RE: **Response to Traffic Study Peer Review**
PZC Application #414-19
425 South Cherry Street/Special Permit

Re: PZC Application #414-19
425 South Cherry Street/Special Permit

TO: Planning & Zoning Commission
FROM: Department of Engineering *AMK*
RE: **PZC Application #414-19**
425 South Cherry Street/ Special Permit
DATE: May 8, 2020

EXIT-1

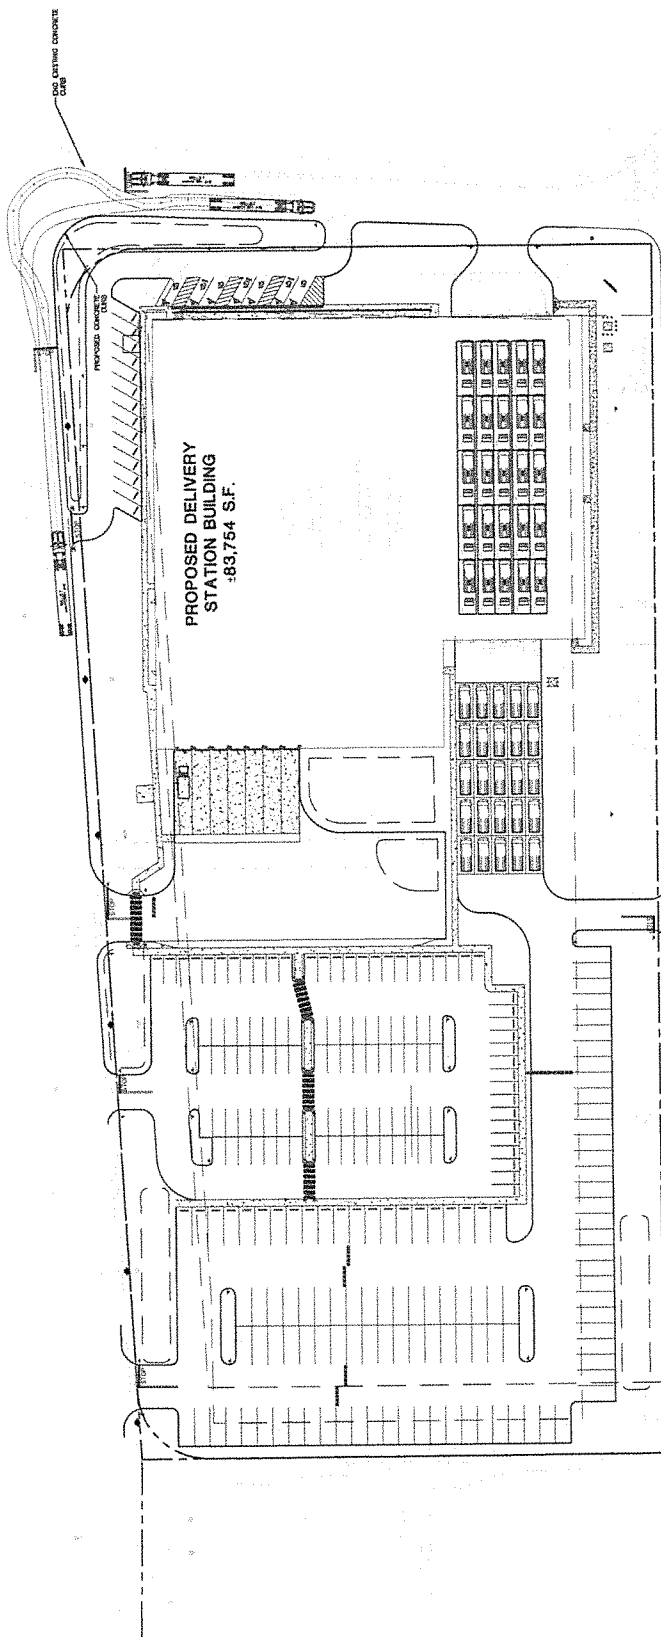
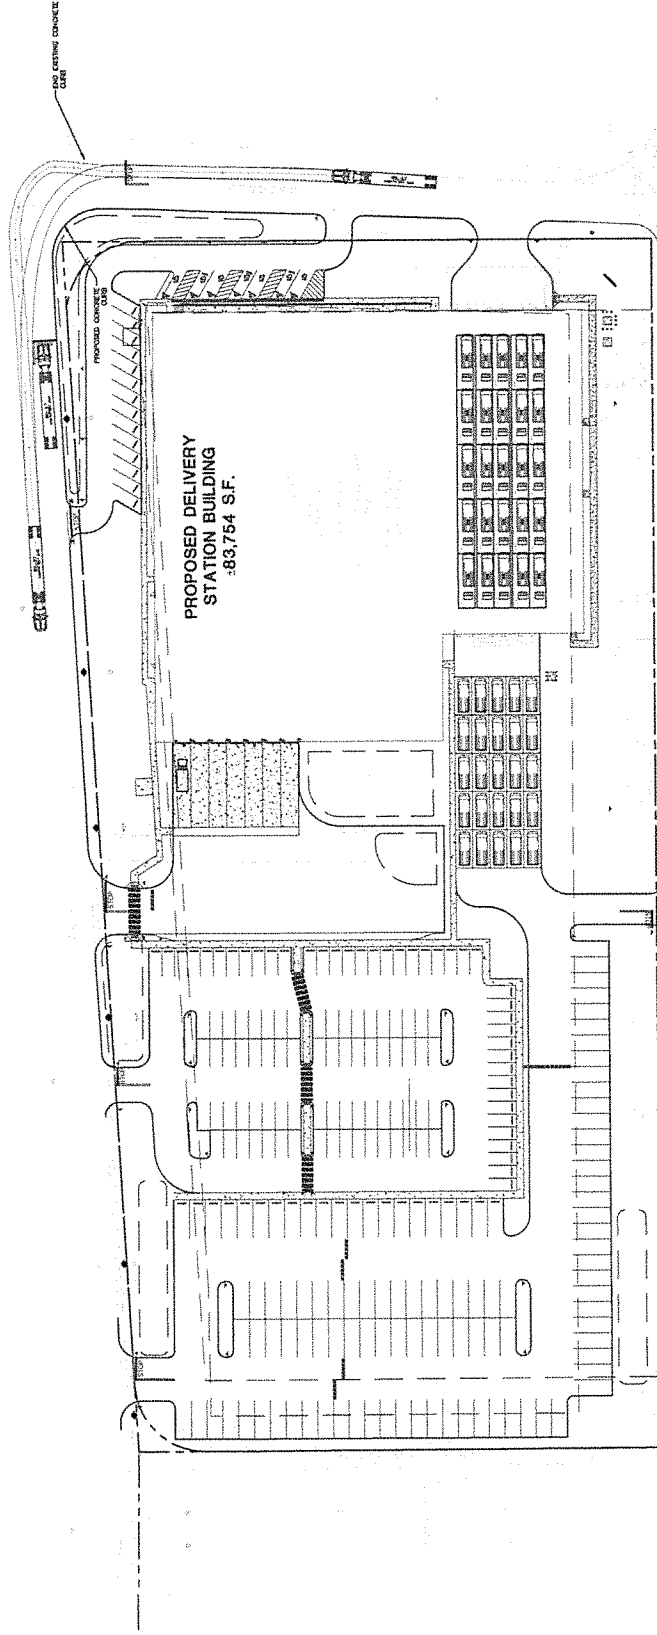
The two stop bar locations at the intersection of Ball Street and Pent Road are different from those on plans Exit-1 and Exit 2. Why?

Another thing: if the stop bar on Pent Road is moved back, the two crabapple trees on the LA plan need to be removed. Please explicitly show on all affected plans that the sight triangle between the two stop bars will be kept clear.

It means you need to use the stop bar locations you showed on the exhibit plans. Otherwise, what's the point of putting together the exhibit plans by running the truck autoturns and not using the results in the submission plan set?

1. I recommend that the commission require the applicant to move the proposed stop bars and associated stop signs for Pent Road and Ball Street on plan SP-2 to locations shown on the most recent truck turning exhibit plans EXTT-1 and EXTT-2 that were sent to the Town Planner and me via email on March 23, 2020. (The dates on the truck turning exhibit plans, 11/26/2019, are incorrect.) In addition, the Landscape Plan should be revised accordingly if proposed trees or plants obstruct sight lines between vehicles at the two new stop bar locations. The purpose of these recommendations is to ensure that tractor trailers will not collide with vehicles stopped on the other road of this proposed all-way stop intersection.

As discussed: does this mean when we adjust the stop sign and bar locations on the SP-1 site plan to match the locations on the EXTT-1 and EXTT-2 plans; that you are content with the plans?

Yes understood, I apologize. The SP-1 plan has a drafting error. The intent is to have the traffic controls as shown on the EXTT plans.
